Project	Creekview Ranch School Campus Expansion – Site Package
Client	Dry Creek Joint Elementary School District
Date	07/21/2026
Project Number	Y2514.00
Agency Number	02-123892 Inc. 01

End of Addendum Number 03

C2.1
AD3.06

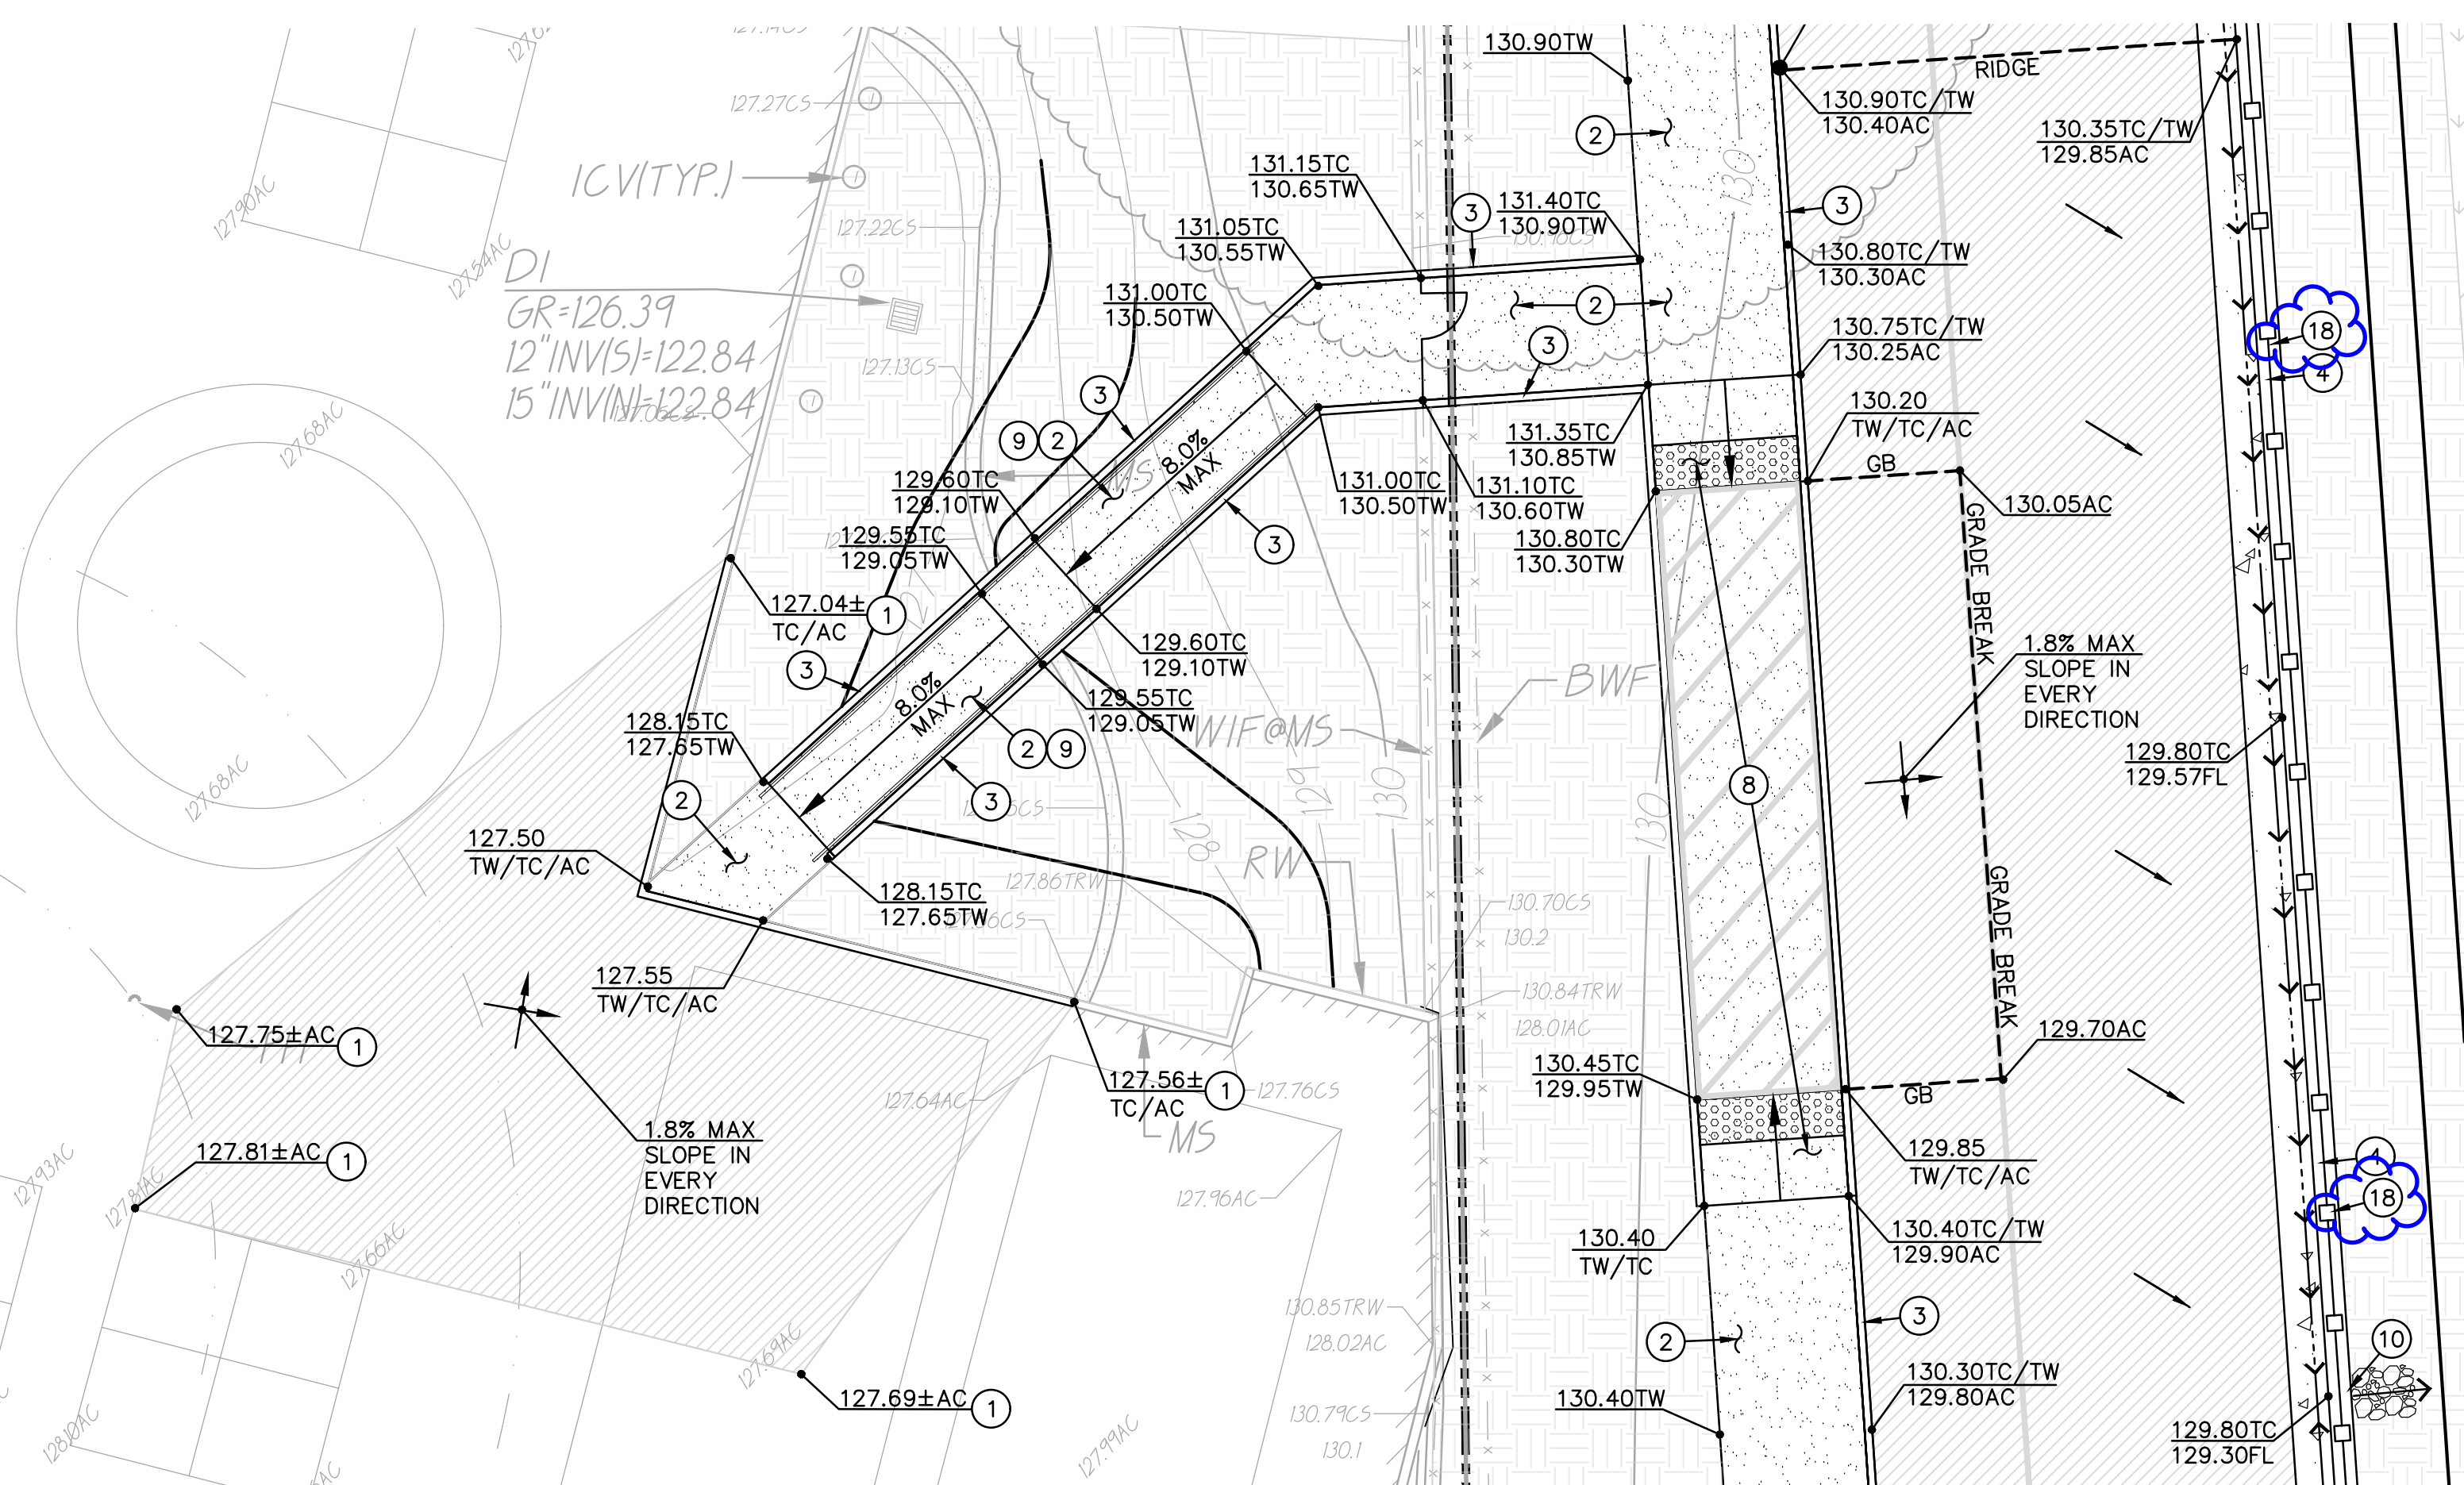
Q#1: Detail 9/A105 calls for out "mow strip per 13/C6.1 where occurs on plans". Sheet C6.1 is the erosion control plan and doesn't have a detail 13. We're assuming a mow strip is required under the new fencing to match existing conditions. Please confirm a mow strip is required under all new fencing and provide detail.

R#1: New mow strip is required under new fencing in some areas – keynote 18 was added on C2.1 and C2.2 to show locations of new mow strip and Detail 15/C7.2 been added, see attached sheet.

- AD3.03** Sheet L3.1 – Sprinkler Irrigation Plan
- Update all Leemco piping to PVC Schedule 40
- AD3.04** Sheet L4.2 – Sprinkler Irrigation Details
- Remove Detail 2, Detail 3, Detail 4, Detail 5, Detail 6, Detail 7
 - Update Detail 8
- AD3.05** Sheet L4.3 – Sprinkler Irrigation Details
- Update Detail 1, Detail 2, Detail 3, Detail 4
- AD3.06** Sheet C2.1 – Grading Plan
- Added Keynote 18 and placed on all views
